2. Pease Subdivision Meadowmere Replat

KPB File 2023-064

ITEM 2 - PEASE SUBDIVISION MEADOWMERE REPLAT

STAFF REPORT

PRELIMINARY
PLAT

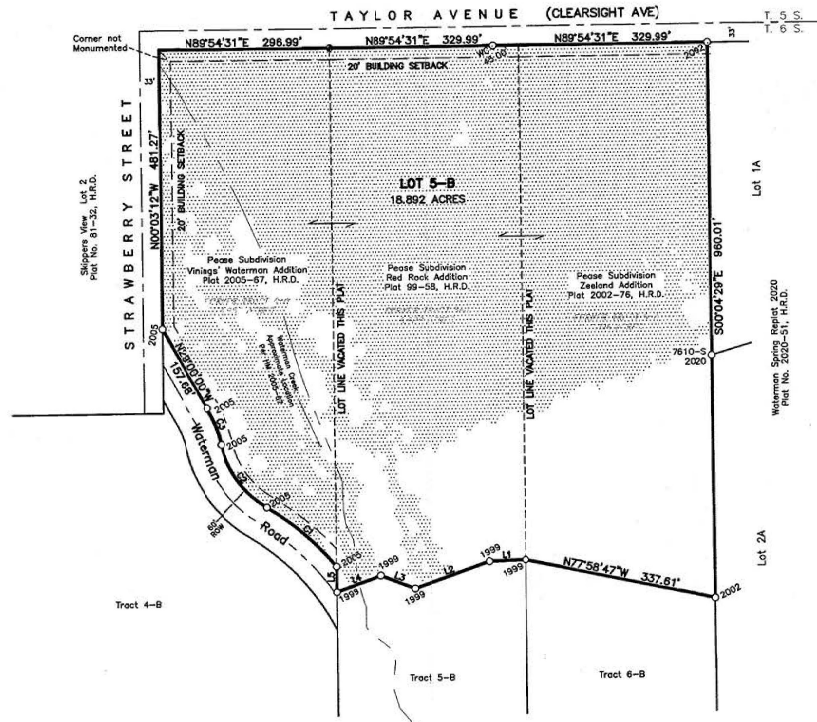
Pease Subdivision Red Rock Addition HM 99-58 at plat note #6 grant a 25 foot ingress / egress easement on Waterman Canyon Road that needs to be shown.

According to staff research there is a 66 foot wide section line easement on the north boundary of the subdivision.
Staff recommends: the easement be shown and the width depicted.

Please transfer all notes forward from the parent plats as necessary.

Utility Easements Each replat of the subject parcels has granted utility easements for overhead and underground utilities. Plat notes are present, but if the easements were depicted on parent plats **staff recommends: the depiction be carried over and the source labeled.**

Per the certificate to plat a general easement granted to Homer Electric Association, Inc. affects Tract 5-A, Pease Subdivision Red Rock Addition, HM 99-58. **Staff recommends: the easement be added to the plat notes if no location is known.**

HEA has requested depiction of an easement along an existing utility and the comment is in the packet. Staff recommends at easement be added to the drawing as requested.

- Remove plat notes nine as it does not affect this subdivision.
- Add the KPB number to the title block.
- Add note for easement at volume 209 page 629 as shown on the certificate to plat at #10

Staff recommendation: Waterman needs to be added to the parent plat name for Tract 4-A.

The owner's name should match how Jeffrey Dean is in title. If the spelling is correct "also known as" or "acquired title as" should be added to the signature block.

The more or less should be removed and the exact acreage shown on the final plat.

Staff recommendation: Remove Taylor Avenue as the name is Clear Sight Avenue currently. Clear Sight Avenue also has varying widths. These should be depicted and labeled.

Staff recommendation: The label for Miller's Landing should be removed and a label for Palmer Creek be added.

Spelling of Borough on the map.

Add Kachemak City and Homer limit lines to the map.

Staff recommendation: A preliminary plat has been received for Lot 2, Skippers View to the west. The status of the plat should be requested before mylar records.

Staff recommendation: the areas with over 20 percent grade remain on the final.

PRELIMINARY
PLAT

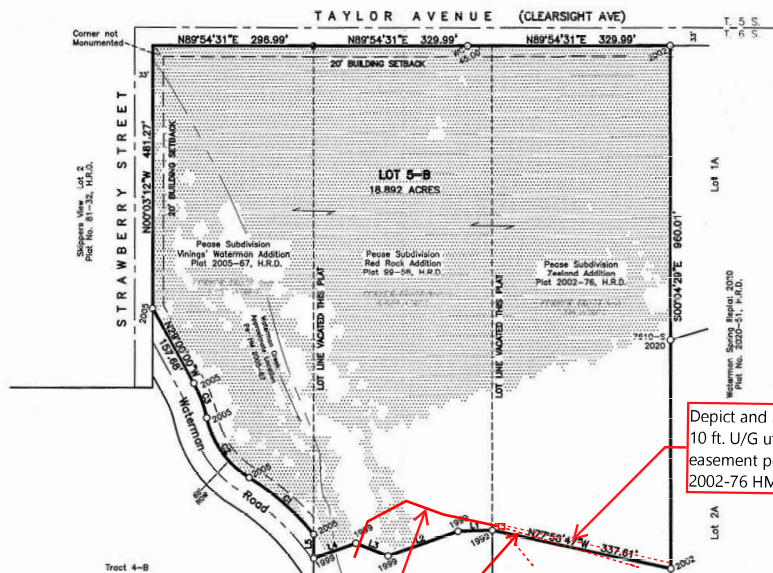
The easements granted per plat 2005-67 for electric lines are not located within former Tract 4-A and can be removed from this plat note.

Depict and label the 10 ft. U/G utility easement per plat 2002-76 HM.

Provide a label or plat note stating, "The existing underground power line is the centerline of a 15-foot-wide electrical distribution line easement, including pedestals and transformers, granted this plat." The approximate location of the underground primary line, transformer, and underground service lines is depicted. The electric lines depicted on plat 99-58 HM has been changed. This platting action will show the current status of the electric lines.
